ECN/PCN No.: M1670

<b>Product Description:</b> Lithium Ion Hybrid Supercapacitor	<b>Abracon Part Number / Part Series:</b>  AHCR-S04R0S	<input type="checkbox"/> Documentation only <input checked="" type="checkbox"/> Series <input checked="" type="checkbox"/> ECN <input type="checkbox"/> Part Number(s) <input type="checkbox"/> EOL
<b>Affected Revision:</b> C	<b>New Revision:</b> D	<b>Application:</b>  <input type="checkbox"/> Safety <input checked="" type="checkbox"/> Non-Safety

**After Change:**

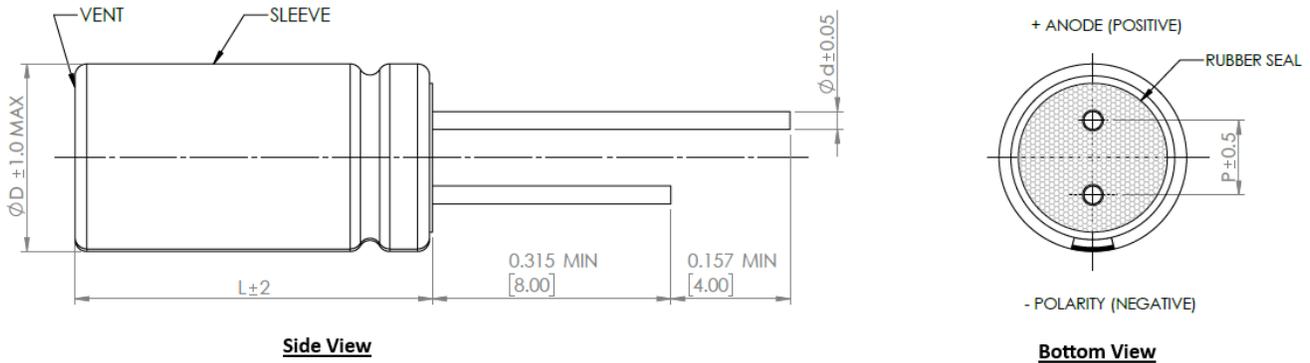
RED part numbers have been discontinued

BLUE part numbers have been added to the series.

Yellow parameters have changed

New rubber seal design for more robust performance at elevated humidity levels. Adding new parts and discontinuing redundancy.

The mechanical changes to AHCR-S04R0SA107Q described in this document must be carefully reviewed. Body length, body diameter and pin pitch have changed.

The 100F part has been replaced with a smaller sized body increasing the energy density. As a result, the ESR has increased and must be carefully reviewed.
